**LEVY NUCLEAR PLANT, UNITS 1 AND 2  
DOCKET NOS. 52-029 AND 52-030  
SUPPLEMENT 1 TO RESPONSE TO NRC RAI LETTER 109 – STABILITY OF OFFSITE  
POWER SYSTEMS**

**Levy Nuclear Plant Units 1 and 2 (LNP)  
Supplement 1 to Response to NRC Request for Additional Information Letter No. 109  
Related to SRP Section 8.3, Dated 8/15/2012**

**NRC Letter No.:** LNP-RAI-LTR-109  
**NRC Letter Date:** August 15, 2012  
**NRC Review of Final Safety Analysis Report**

**Subject:** SRP Section 08-03 – Stability of Offsite Power Systems

AP1000 PLANT RESPONSE TO A LOSS OF A PHASE  
IN THE HIGH VOLTAGE SWITCHYARD

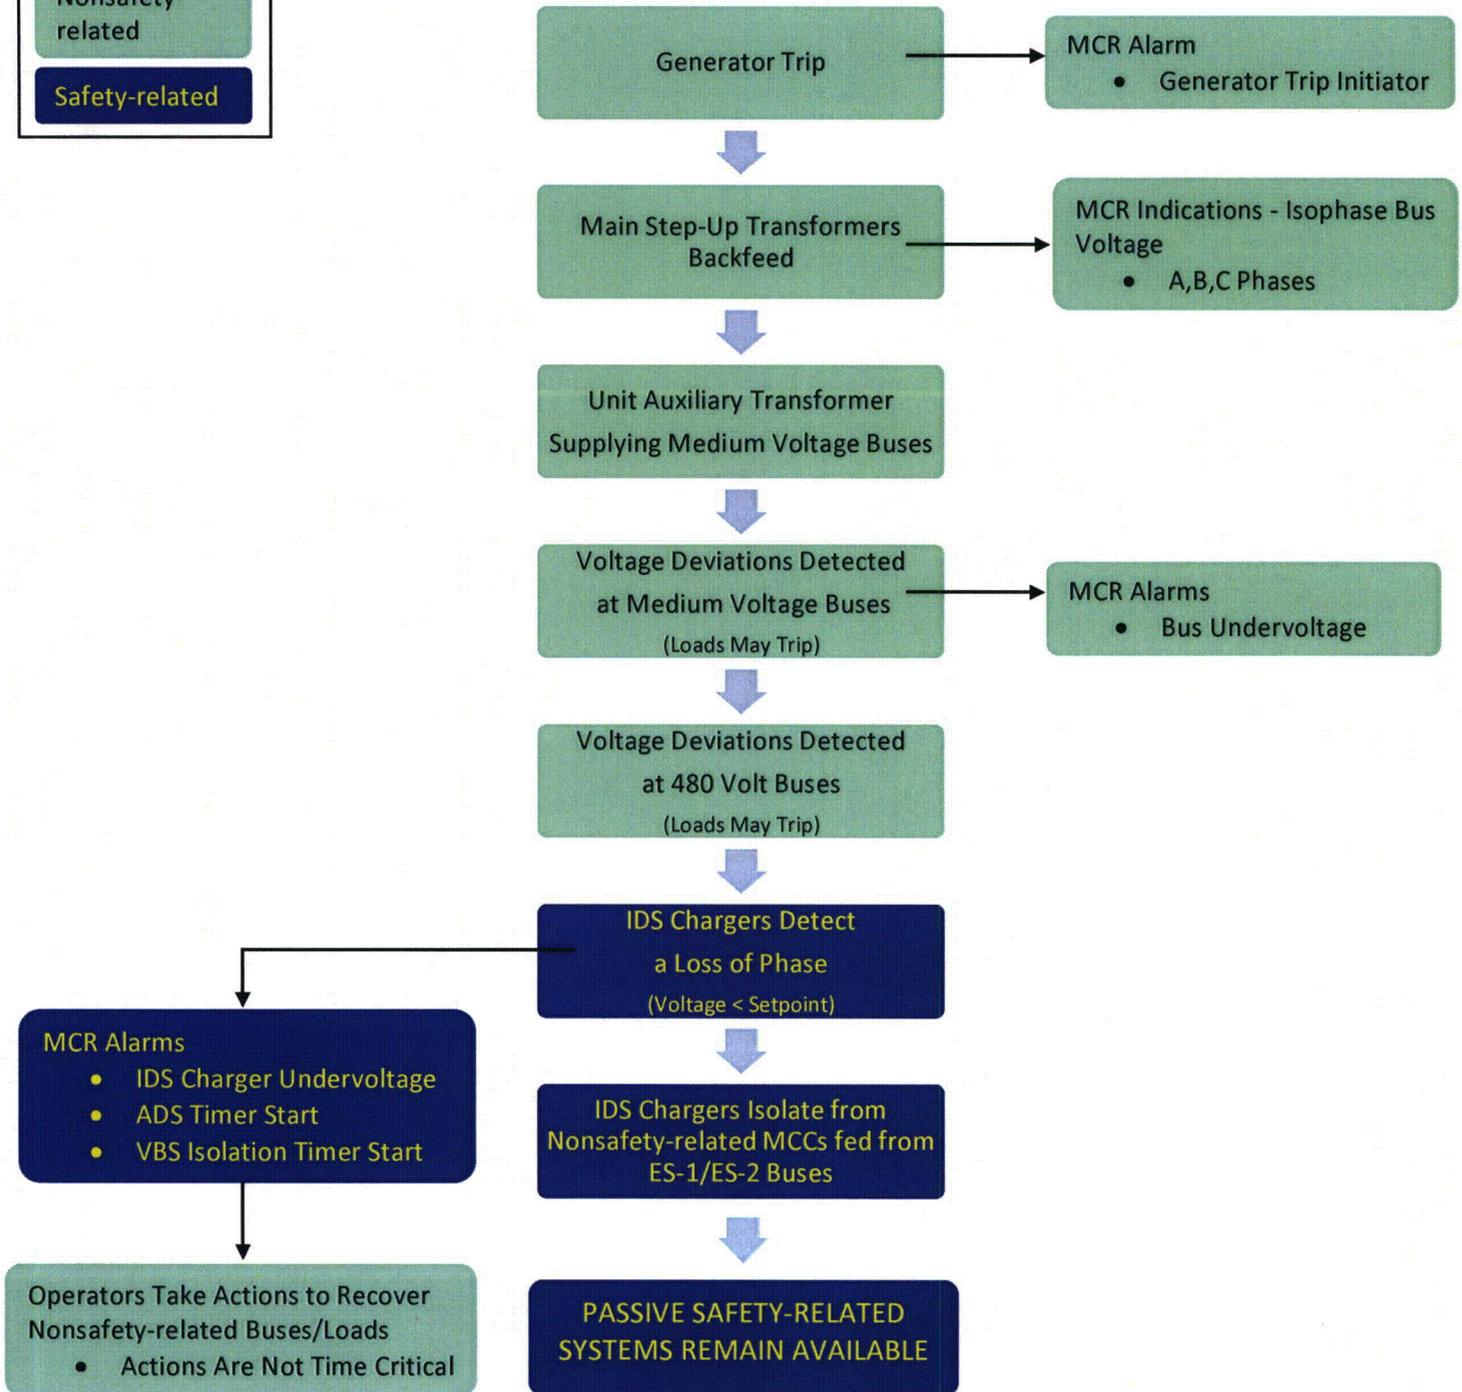
A summary description of the AP1000 response to a loss of a phase in the high voltage switchyard is also presented in the form of a flow chart as Attachment 1 to this letter to aid in understanding the capability of the existing AP1000 design to safely respond to a high voltage open phase condition. Attachment 2 provides additional detail regarding the compliance of the AP1000 design with the NRC General Design Criteria (GDC) 17.
